**RE: CL&P Review of the Connecticut Ground Source Heat Pump (GSHP)
Impact Evaluation and Market Assessment**

The Connecticut Light and Power Company (CL&P) is pleased to submit these written comments with regard to a draft evaluation report: *Connecticut Ground Source Heat Pump Impact Evaluation & Market Assessment* (Study), December 10, 2013, NMR Group, Inc. and DNV KEMA (authors). The draft Study was submitted to CL&P on December 10, 2013 with a request for comments to be provided by January 15, 2014.

Figure 1-2. DOE-2 New Construction Model GSHP System Power vs. Temperature

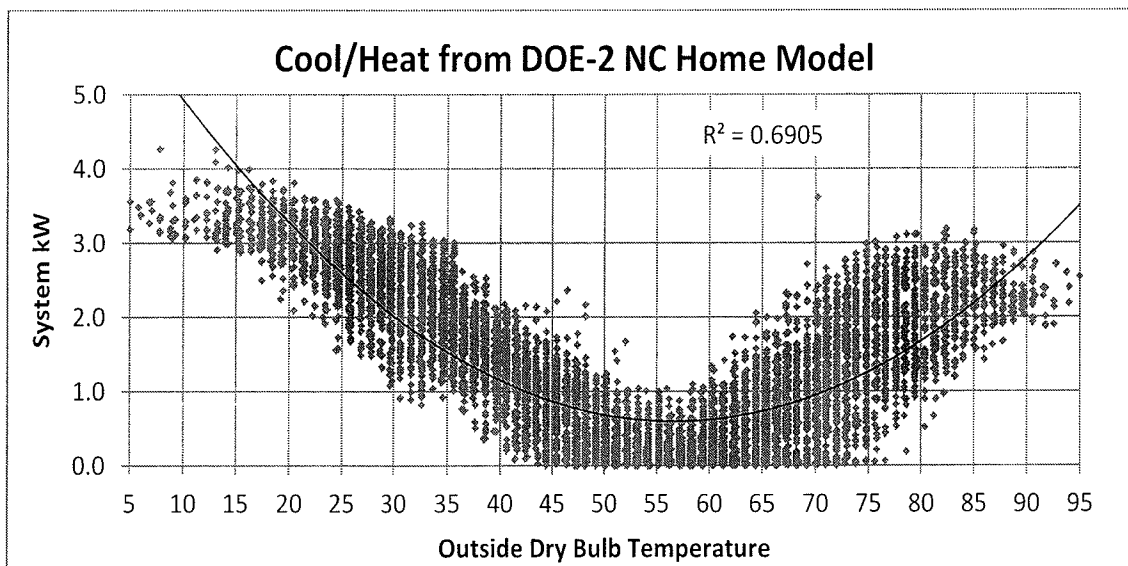
Metered Data. Based on Figures 1-1 and 1-2 from the Study, systems appear to be using significant amount of energy during shoulder periods. For example, based on Figure 1-2 (reproduced below) and normal weather patterns, it appears this system is using approximately 3,000 kWh annually during periods when there would be little or no heating or cooling load. Figure 1-1 shows similar results. This finding needs to be examined to identify what this energy is being used for (fan, standby load and zone controls, water, other), and appropriate recommendations made to reduce this load and increase energy savings.
